service bulletin

No. 91-18

Thermostat Change – 75 thru 115

Mariner and Mercury 1991 75-115

120°F Thermostat P/N 14586

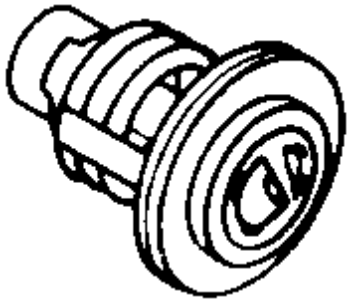
Previous 70/75/80/90 3 cylinder and 100/115 4 cylinder models have a 143°F thermostat installed. Operation at idle for long periods of time in extremely warm water (80°F and above) could cause the block to function hotter than desired. Installation of the 120°F thermostat improves the durability of the engine when operated for long periods at idle.
